Jones Gillam Renz Architects

The Residence at Green Meadow – JGR Proj 24-3395

ADDENDUM NO. 1

E1.4

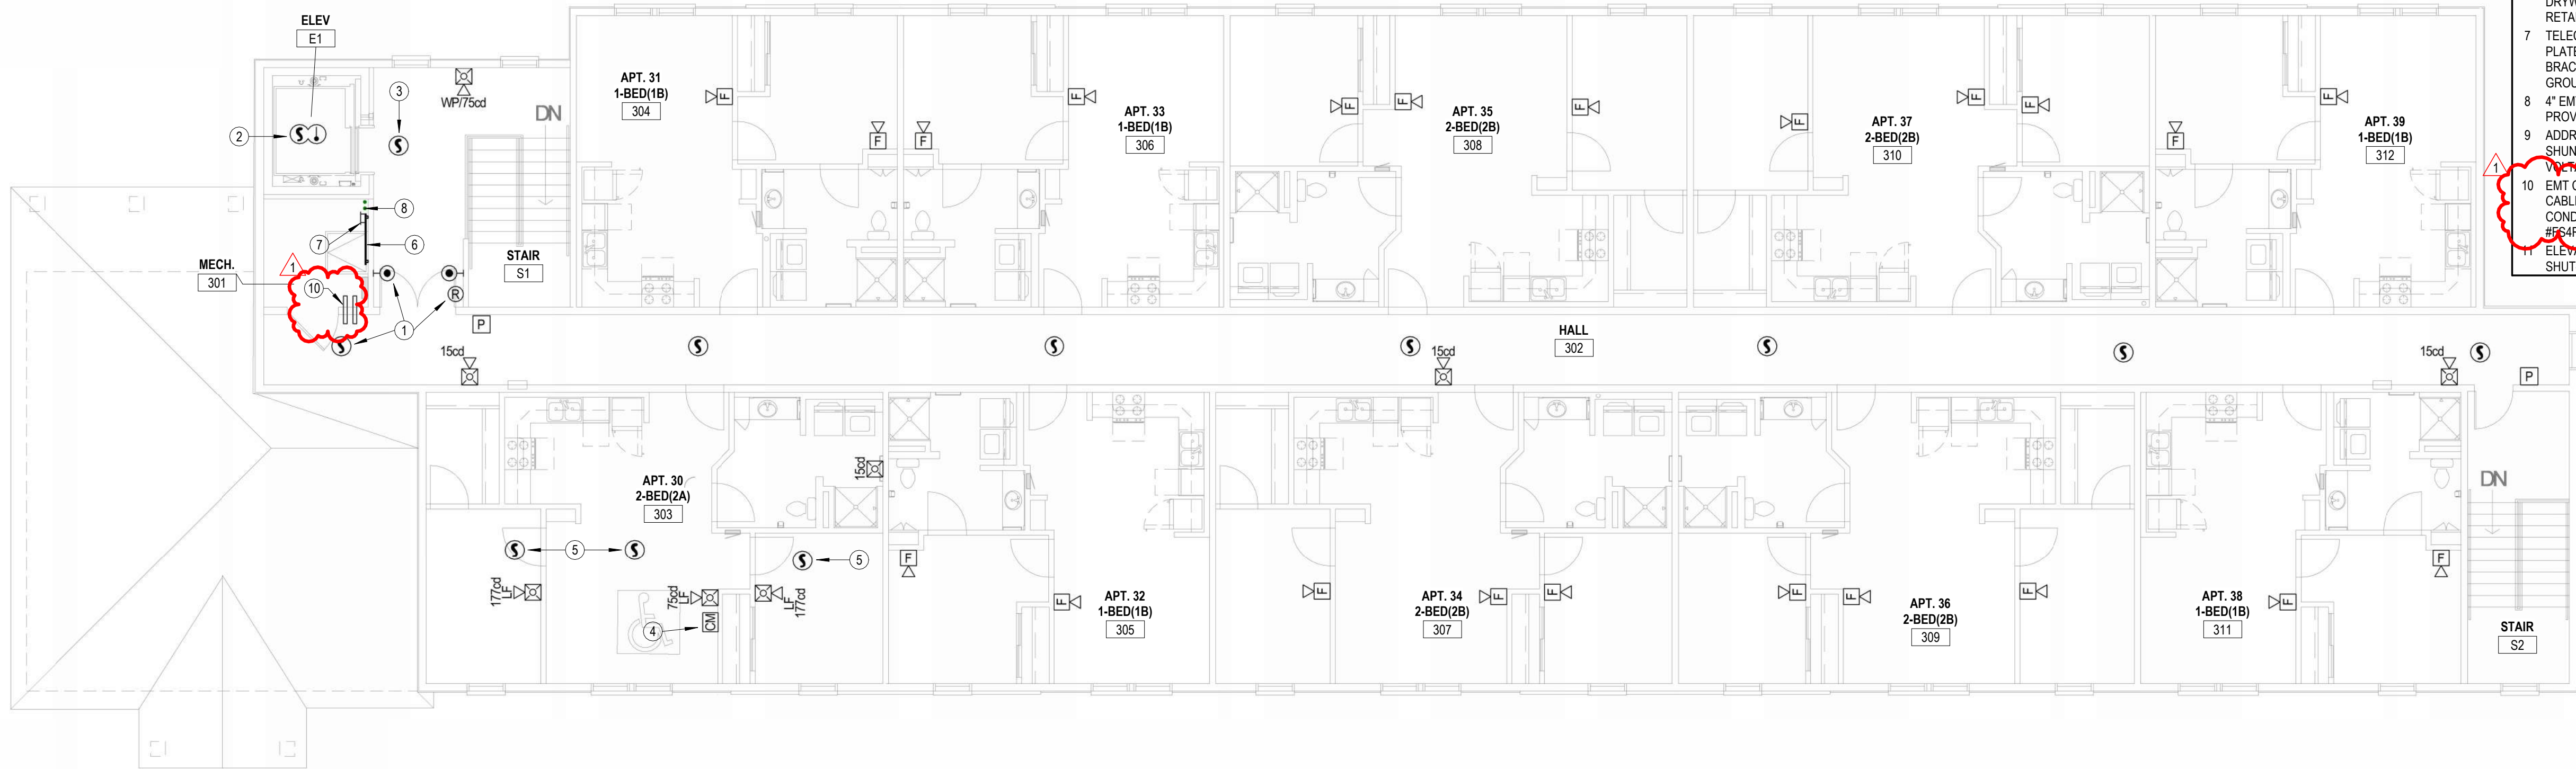
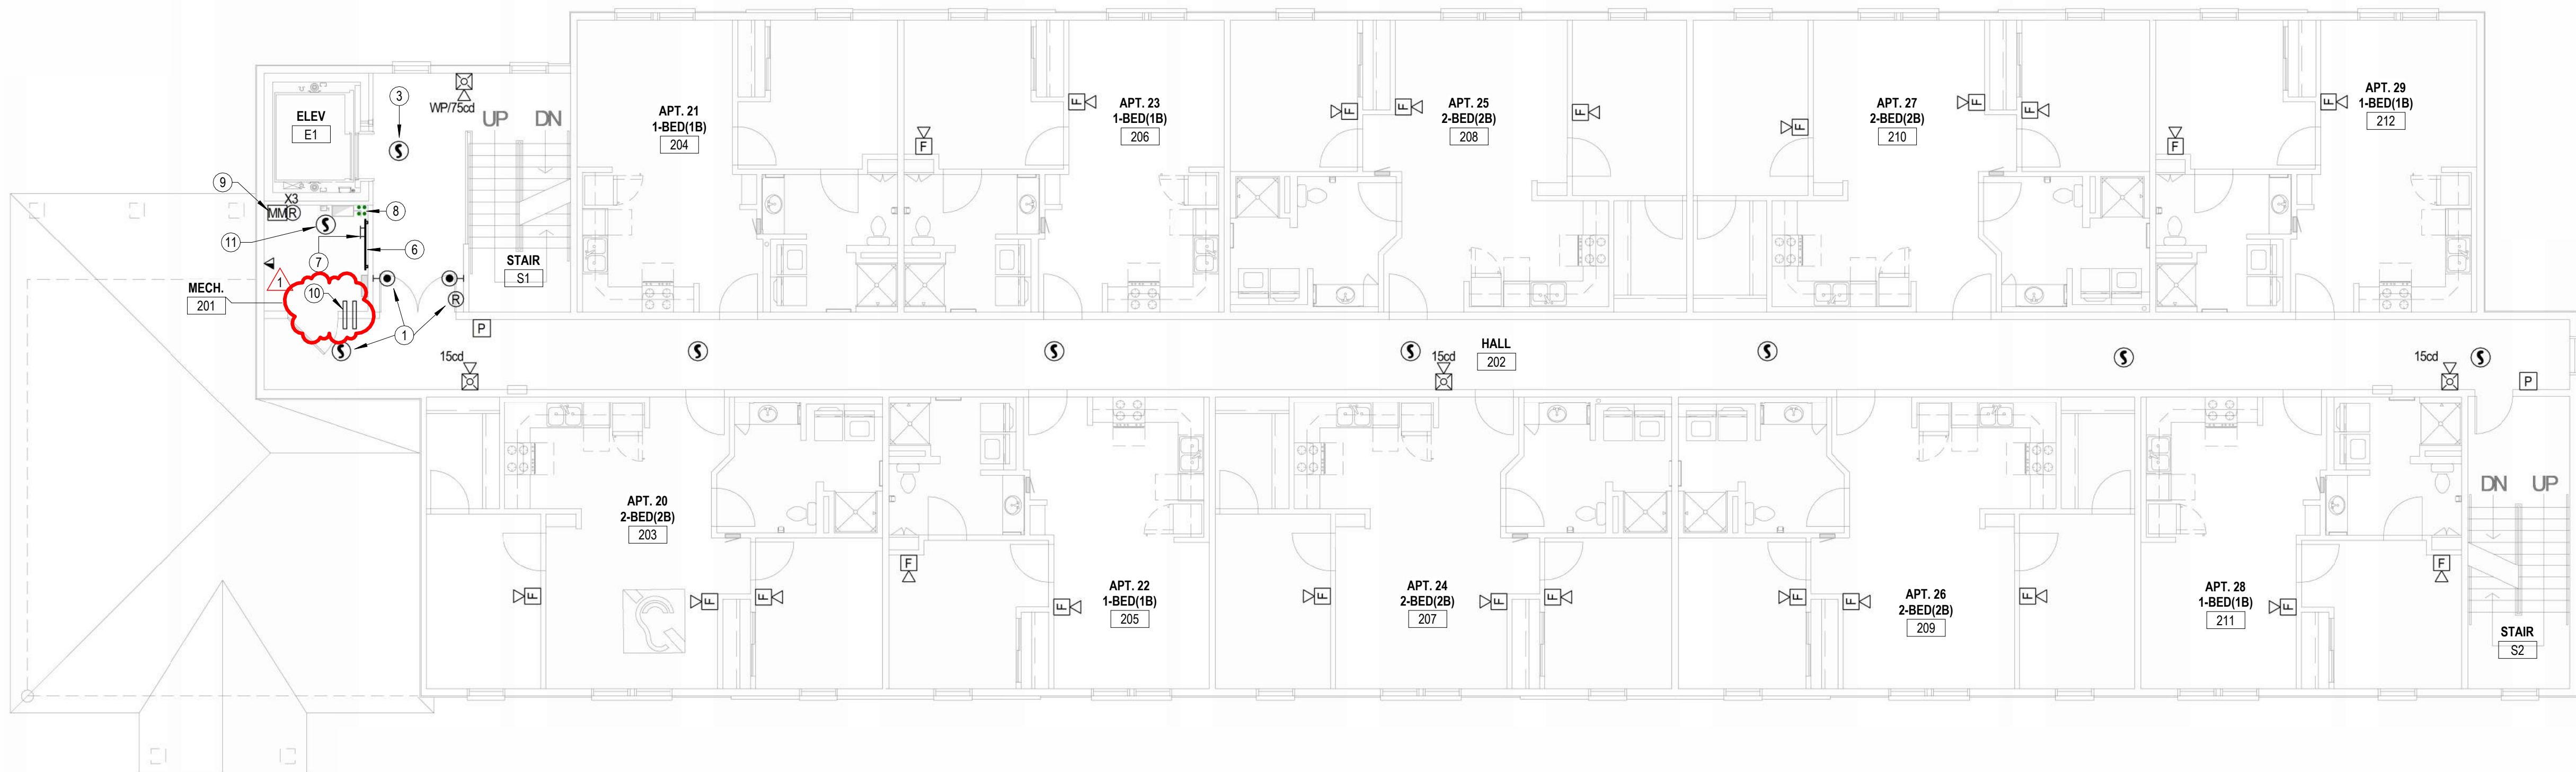
- b. Added IECC compliance note
4. Sheet E1.4
 - a. Added telecom conduit and notes
 - b. Added IECC compliance note
5. Sheet E4.1
 - a. Added doorbell and notes

PROJECT SHALL COMPLY WITH ALL REQUIREMENTS OF 2021 IECC
-NOTE: OUTLET BOXES ON EXTERIOR WALL SHALL BE AIR-TIGHT
BOXES PER SECTION 402.5

M1.2

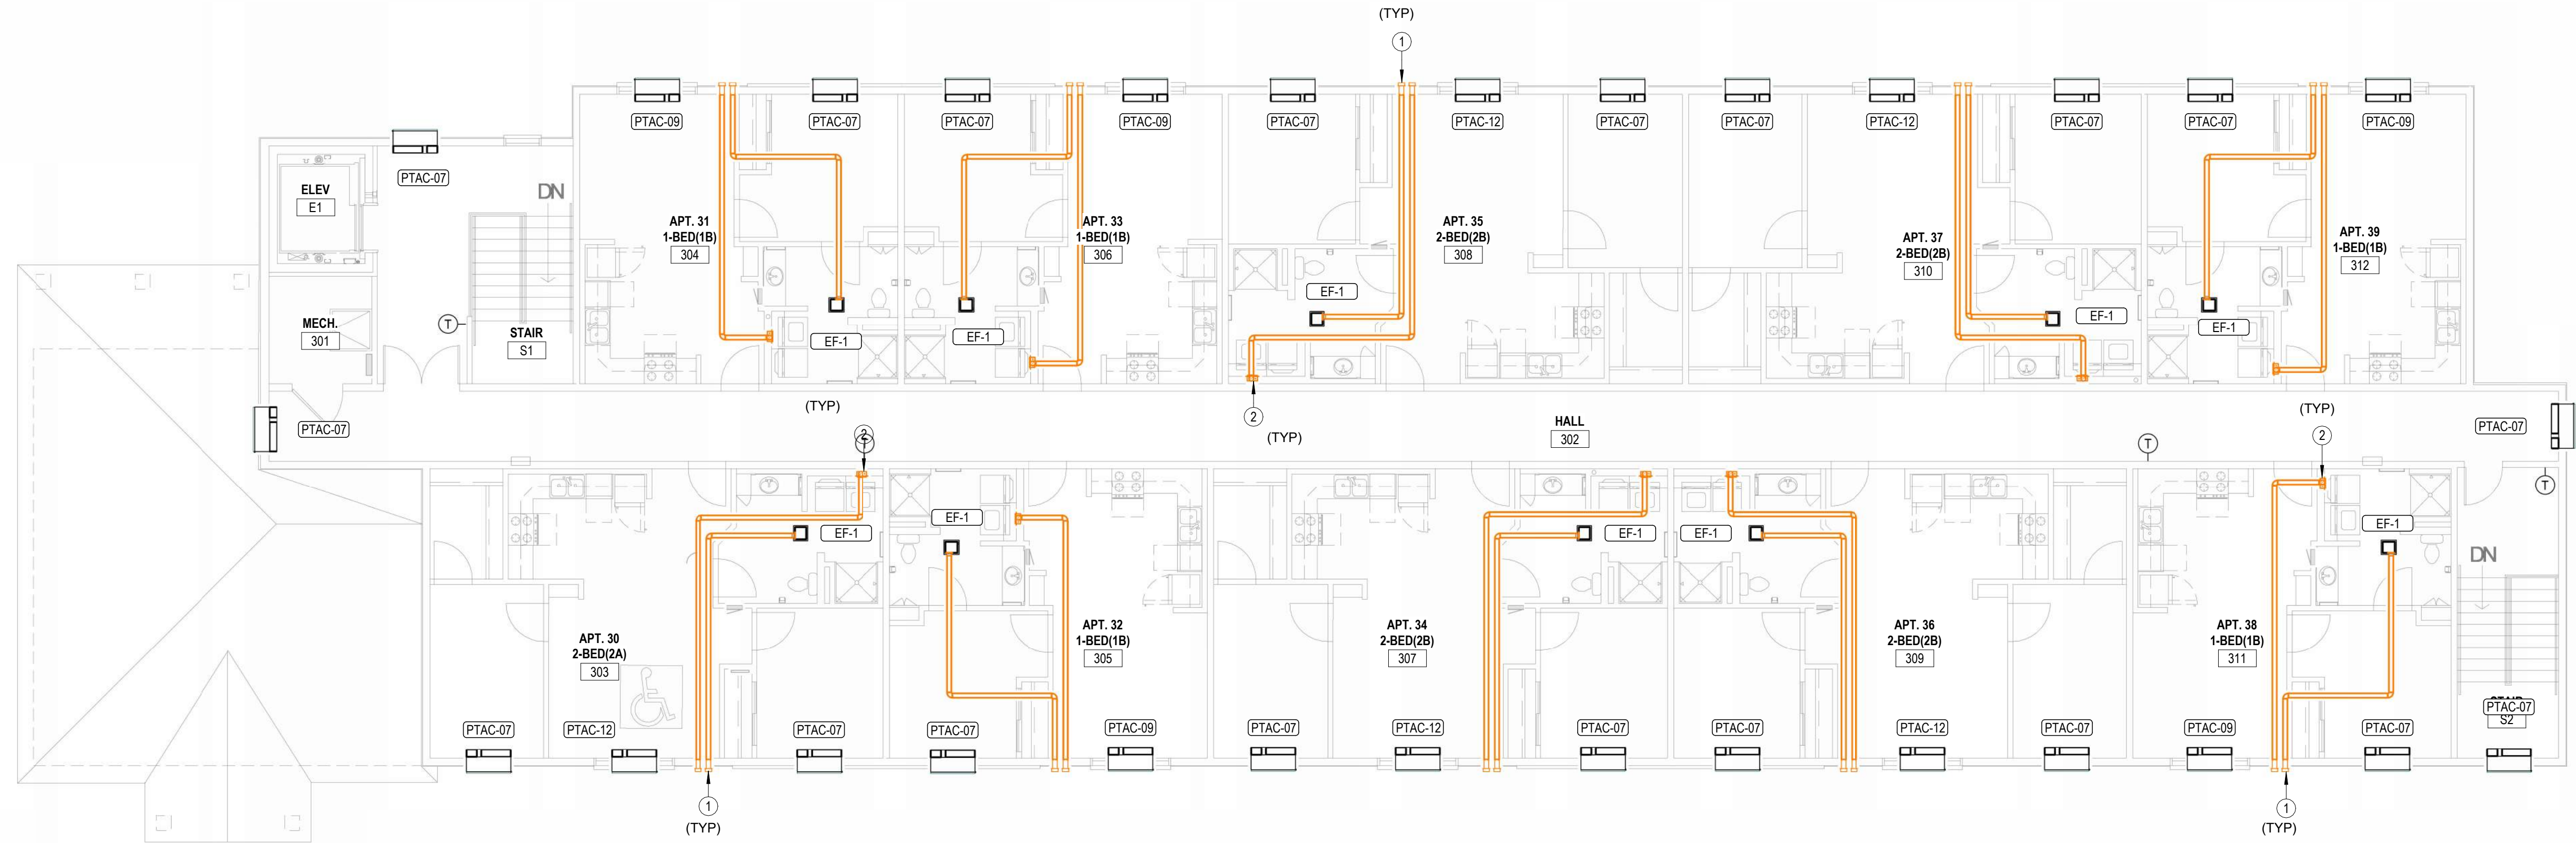
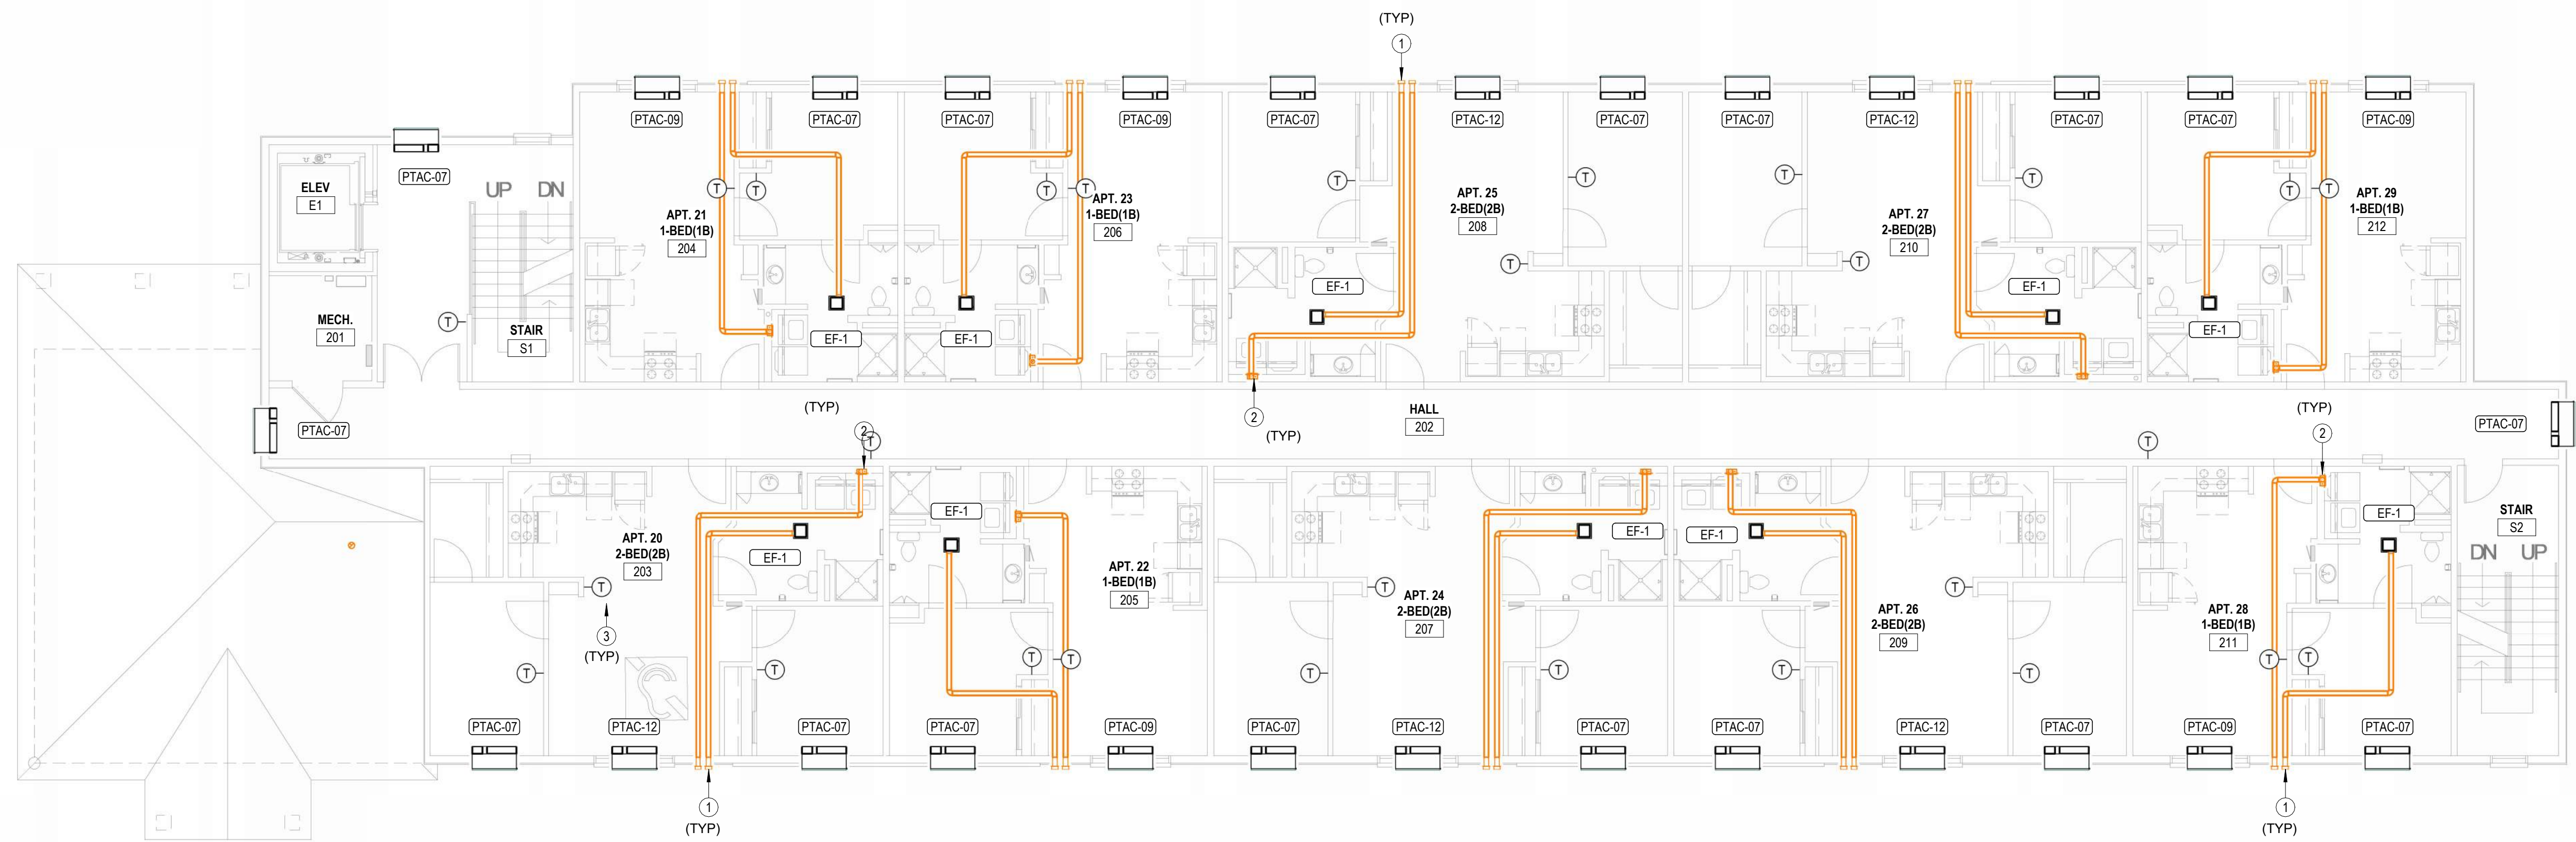
- b. Modified washer/dryer receptacles
 - c. Added IECC compliance note
6. Sheet E6.1 – Added doorbell detail
7. Sheet M1.1 – Added IECC compliance note
8. Sheet M1.2 – Added IECC compliance note

PROJECT SHALL COMPLY WITH ALL REQUIREMENTS OF 2021 IECC

P1.3

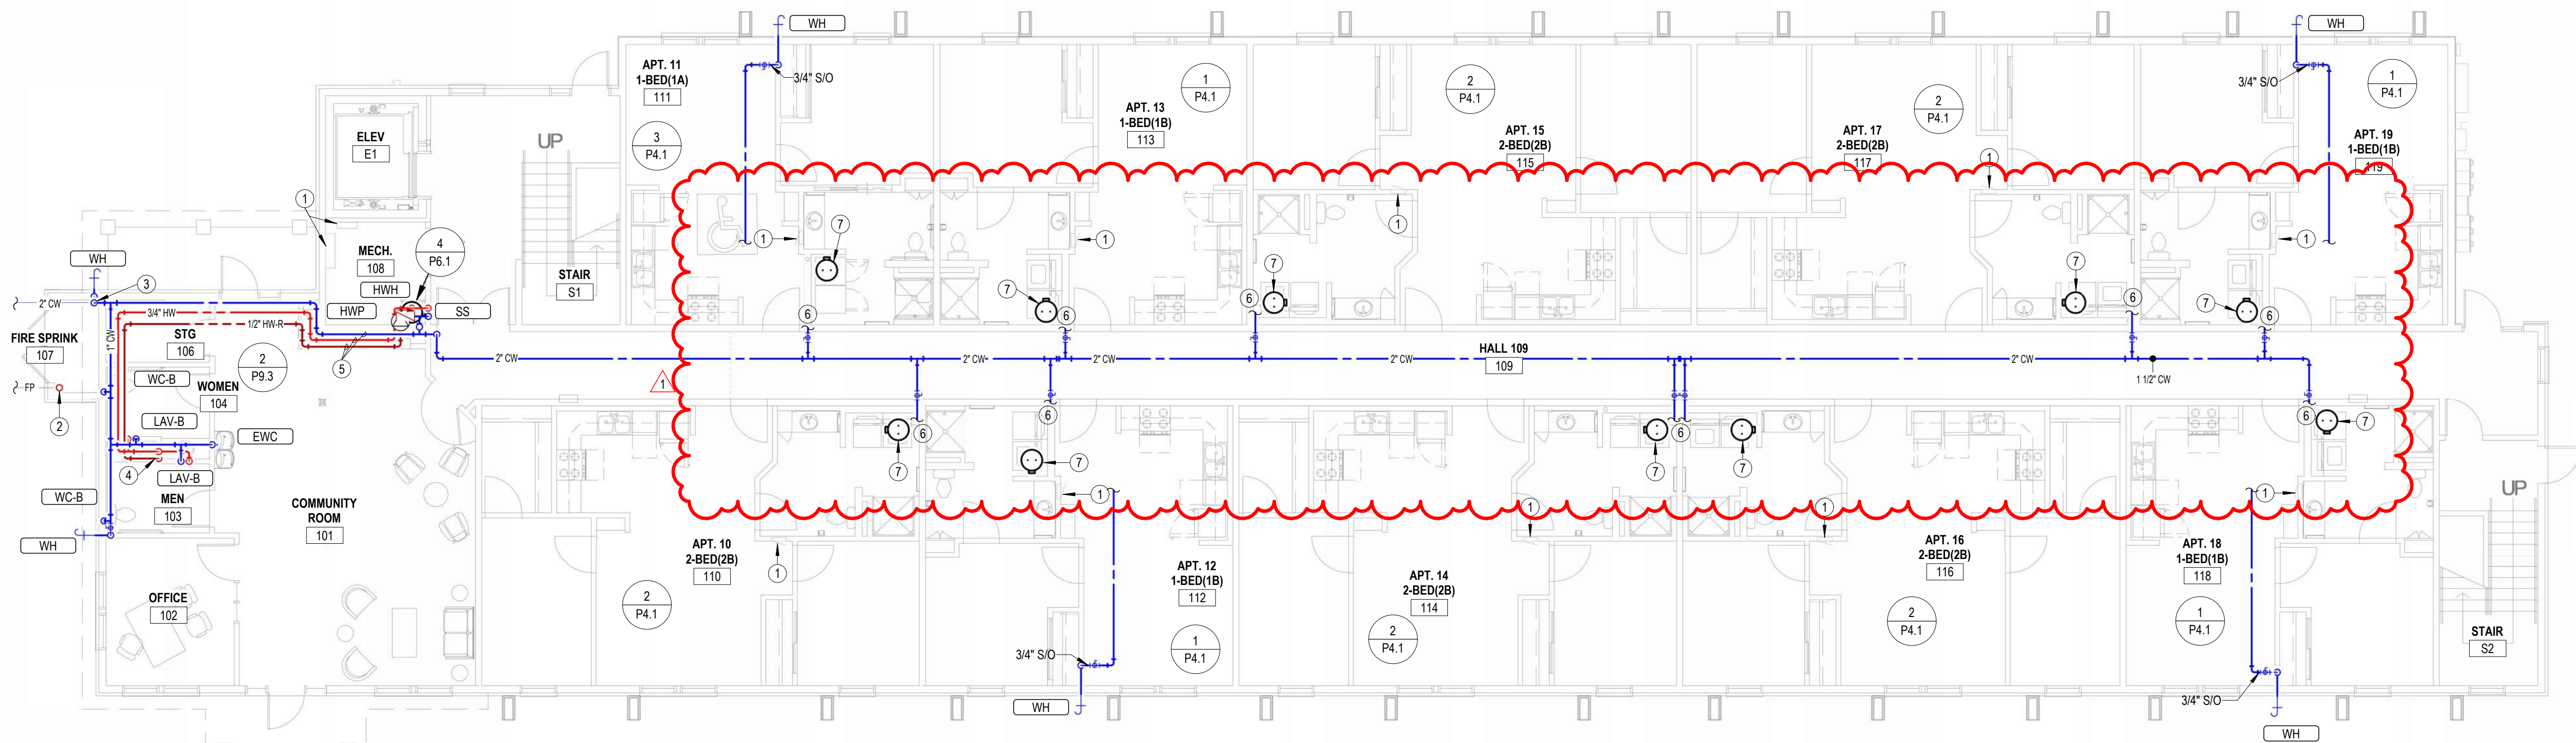
9. Sheet P1.3
 - a. Revised apartment domestic water piping for new HWH location
 - b. Added IECC compliance notes
10. Sheet P1.4
 - a. Revised apartment domestic water piping for new HWH location

PROJECT SHALL COMPLY WITH ALL REQUIREMENTS OF 2021 IECC
-NOTE: DOMESTIC HOT WATER PIPING INSULATION SHALL BE MINIMUM R-3.
